Engineering Report: Assessment of Glint, Glare and Visual Impact from Proposed Green Hill Solar Farm (Green Hill G)

Subject: Preliminary Opinion Assessment of Glint, Glare and Visual Impact from Proposed Green Hill Solar Farm (Green Hill G)

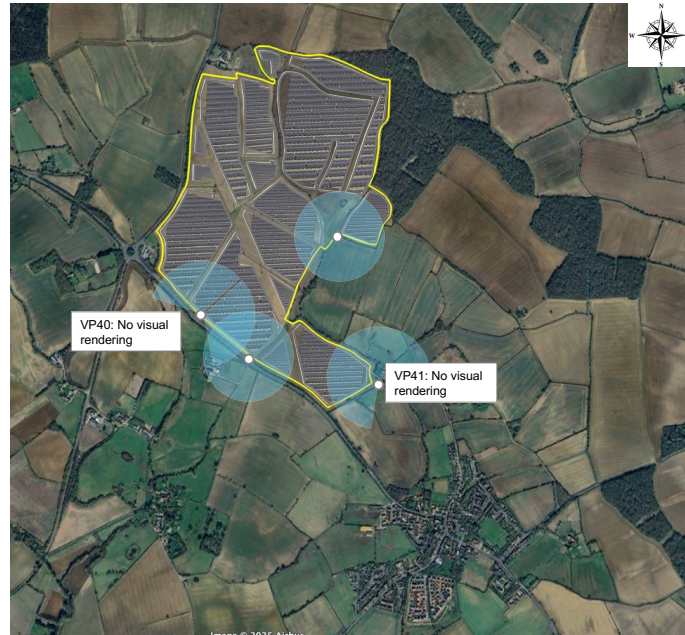
It appears as though no modelling has been undertaken for users of the Three Shires Way (TSW) – despite high usage and narrow path making glare unavoidable. Equine safety risks specifically have been glossed over. The Developer’s reports comparisons to natural reflections are inaccurate, and guidance from the British Horse Society

misapplied. This constitutes a misrepresentation of facts and avoidance of relevant guidance – this needs to be investigated correctly and included in the Developer's reports for completeness and transparency.

A personal rendering of the impact of the proposed PV panels on horse-riding along the Three Shires Way is as follows:

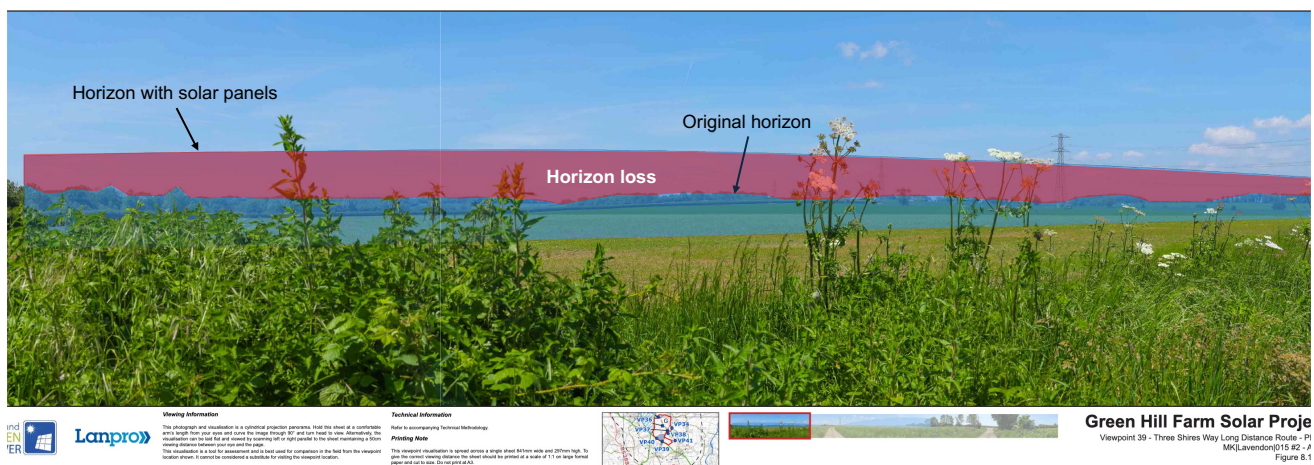
Apart from the visual impact assessment, it is not clear if the issue of horizon loss or horizon distortion has been included. Horizon loss or horizon distortion is the adverse aesthetic or perceptual impact that occurs when an introduced artificial structure (such as a building, solar array or wind turbine) intercedes or obstructs the natural, uninterrupted line of sight to the horizon, sky, or continuous natural ground plane.

It is a form of visual degradation where the perceived boundary between land (or water) and sky is broken, flattened, or replaced by a human-made element, thereby reducing the sense of spaciousness, visual clarity, and scenic quality.
